ORIGINATION FORM

Proposed Revisions to a Standard Plans Index

Index Number: 715-001

Index Title: Conventional Lighting

METAL POLE DETAIL

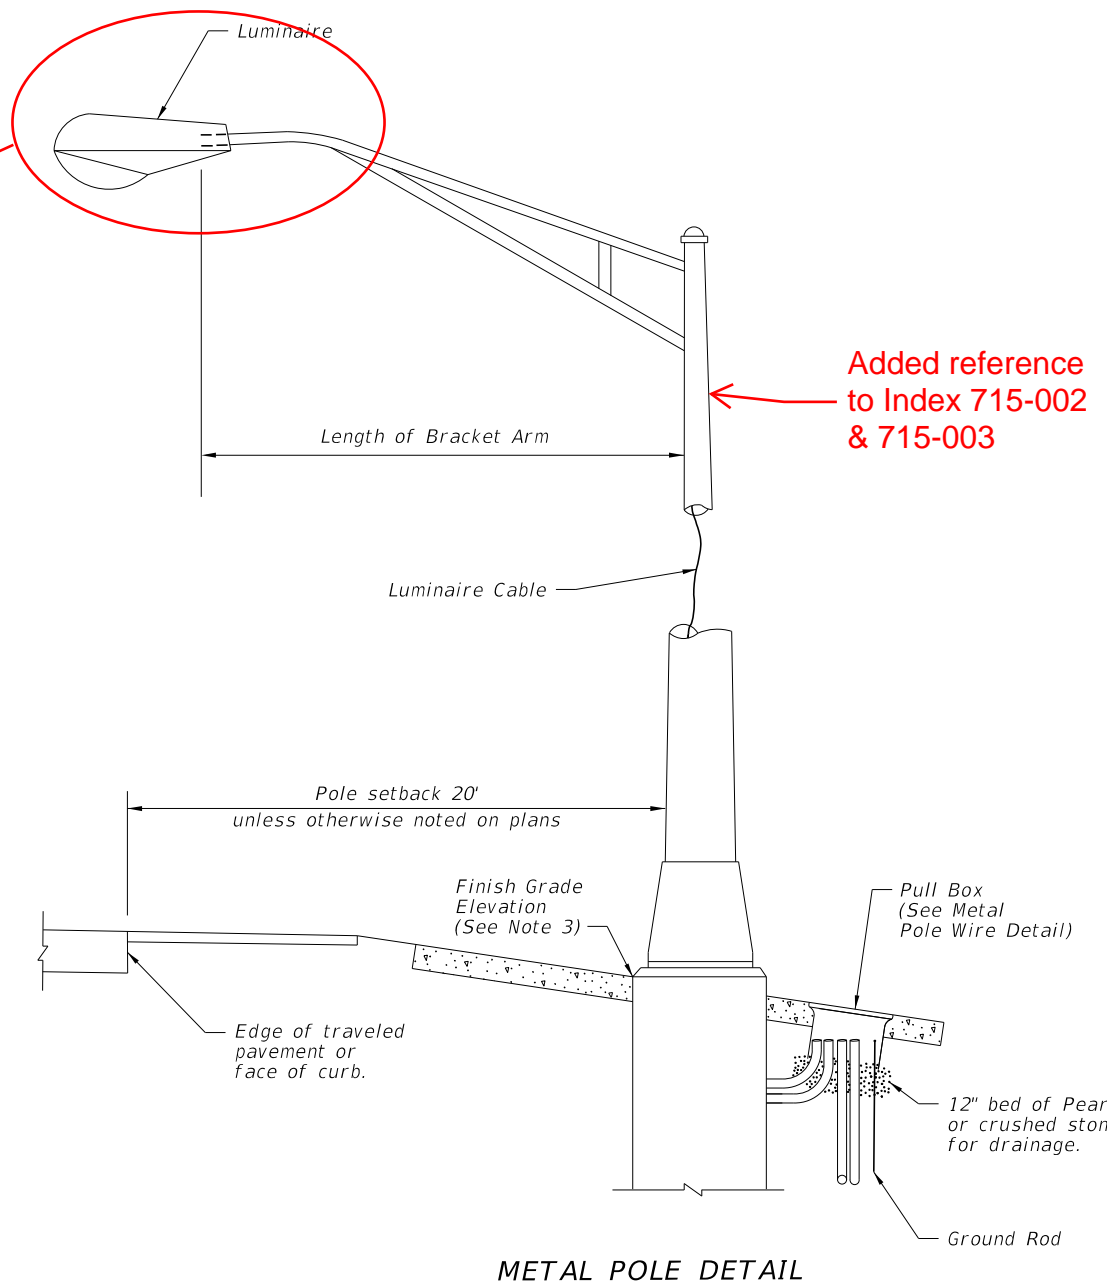
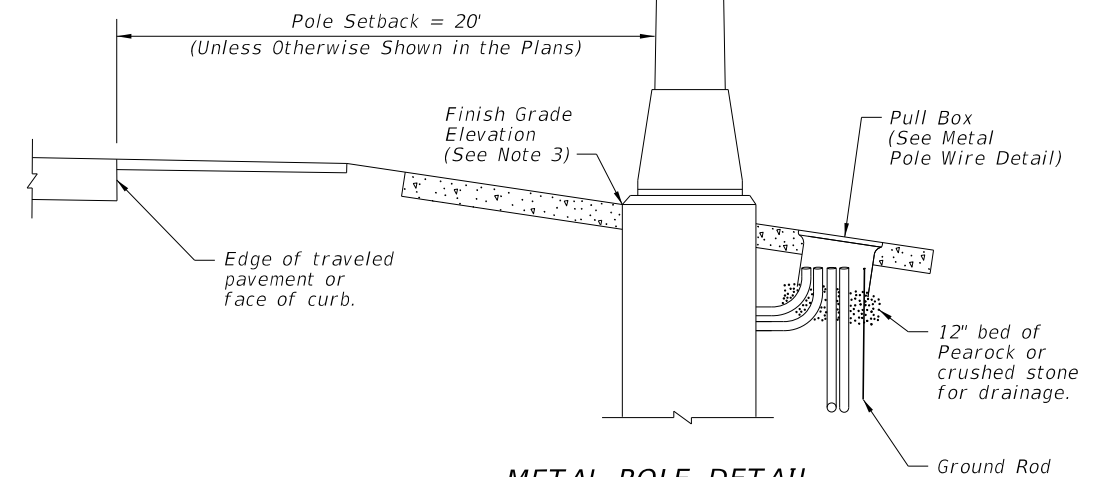
Sheet 1: Added a detail to define luminaire tilt angle for designers and contractors; Added reference to Index 715-002 and 715-003 to the Metal Pole Detail; Changed sheet title to "Wiring and Installation Details" to capture the installation details beyond wiring.

LUMINAIRE TILT DETAIL (Side View)

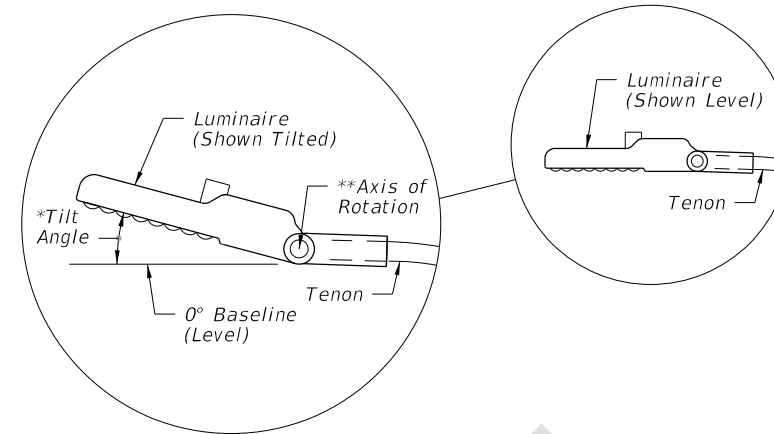
Added "Luminaire Tilt Detail"

*Tilt angle is 0° (level) unless otherwise shown in the Plans
 **Axis of rotation is level and perpendicular to the tenon.
 The location shown is approximate and may be either a hinge or a tenon connection adjustment.
